METROPOLITAN GOVERNMENT OF NASHVILLE AND DAVIDSON COUNTY

Metropolitan Historic Zoning Commission
Sunnyside in Sevier Park
3000 Granny White Pike
Nashville, Tennessee 37204
Telephone: (615) 862-7970
Fax: (615) 862-7974

STAFF RECOMMENDATION
3734 Central Avenue
September 17, 2014

Application: New construction – addition; Setback determination
District: Richland-West End Neighborhood Conservation Zoning Overlay
Council District: 24
Map and Parcel Number: 10409002700
Applicant: Susan Hager, Architect
Project Lead: Sean Alexander, sean.alexander@nashville.gov

SITE DIAGRAM
 SCALE: 1/16" = 1'-0"

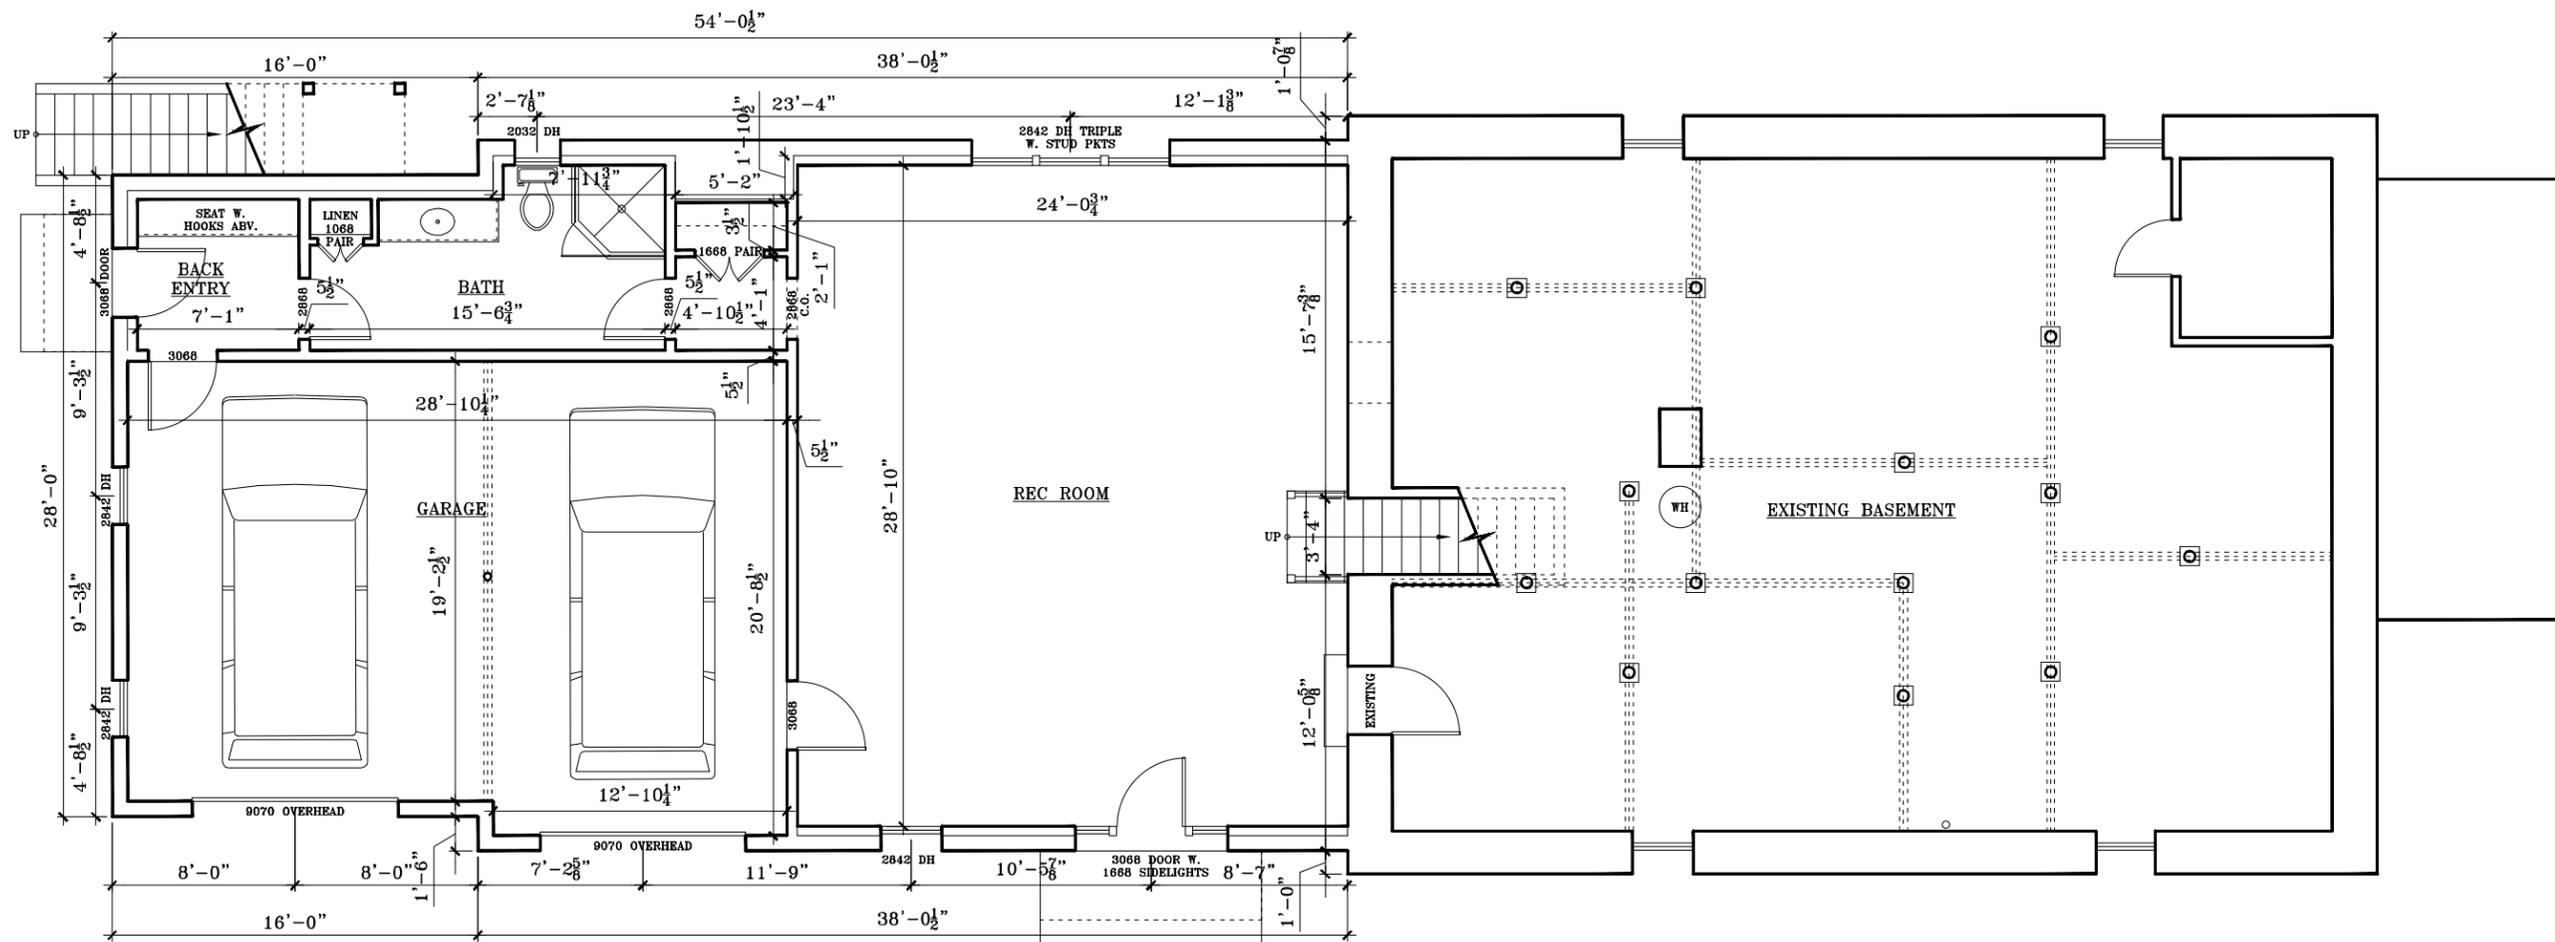
The addition will be located twelve feet (12') from the left side of the property along Christopher Street, and seven feet (7") from the property line on the right side. The proposal would meet the required minimum setbacks for most additions, however, because the addition includes a basement-level garage facing a street, bulk zoning requires a twenty foot (20') setback on the left side. Historically, garages were often located much closer to streets and alleys than current zoning allows, and basement-level garages were historically common in the surrounding area. In addition, the existing house is only approximately ten feet (10') from the property line, but there is a ten foot (10') wide unpaved buffer between the edge of the property and the curb. For these reasons, staff finds that the proposal is compatible with the historic context and meets section II.B.1.c of the design guidelines. Staff finds that the proposed setbacks are appropriate.

The proposal will include two side-facing garage doors on the left side along Christopher Street, in the basement level. The bulk zoning standards require a twenty foot (20') setback for street-facing garages; however the location of the garages will be in roughly the same location as an earlier outbuilding for which the curb cut still remains. In order to minimize hardscape and paving, however, staff recommends as a condition of approval that there be separate driveways and/or driveways strips instead of a single large curb-cut. With that condition, staff finds that the street-facing basement-level garages would be compatible with the historic character of the area, and that the project meets section II.B.1.h of the design guidelines.

- The replacement window in the front gable shall have the same size and proportion as the existing window, and
- Staff shall approve the selection of the windows and doors prior to purchase and installation, and
- There shall be separate driveways and/or driveways strips instead of a single large curb-cut.

CENTRAL AVENUE ELEVATION
SCALE: 1/8" = 1'-0"

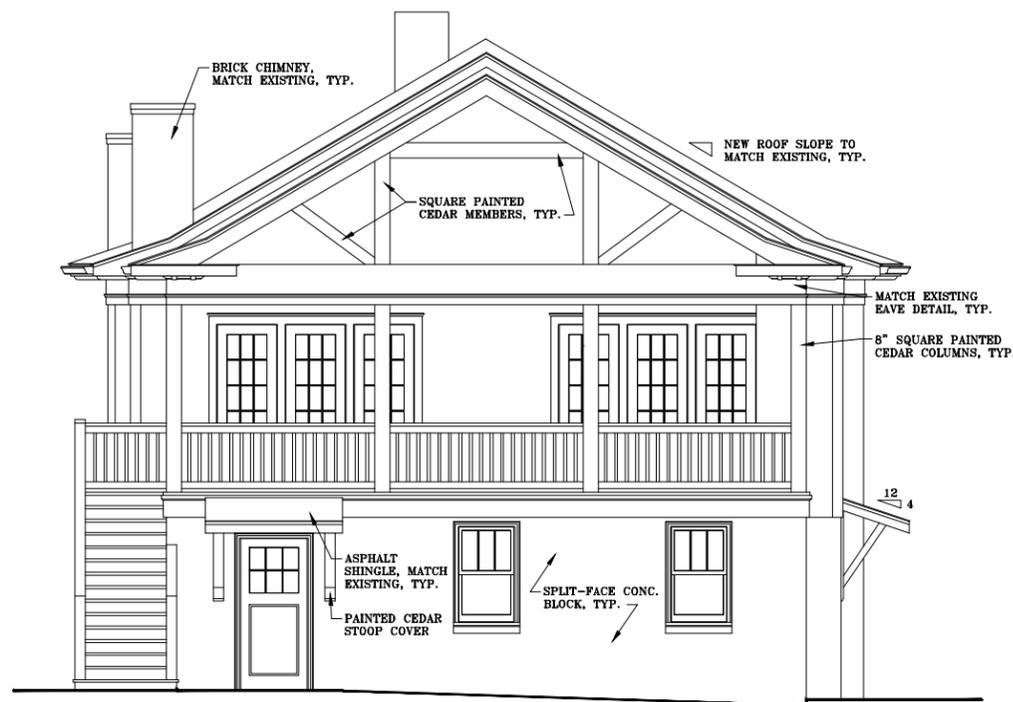
The plans show that a pair of square windows in the upperstory of the historic house would be replaced with a single window in a different size in order to meet egress requirements. Because this window is a character defining feature, Staff recommends that any new window be identical in size and proportion, although it might function as a single window (ex. An awning or a casement with faux muntins would retain the appearance but provide a large enough opening. A second option would be to add a side dormer.) No other changes to the window and door openings on the existing house were indicated on the plans.
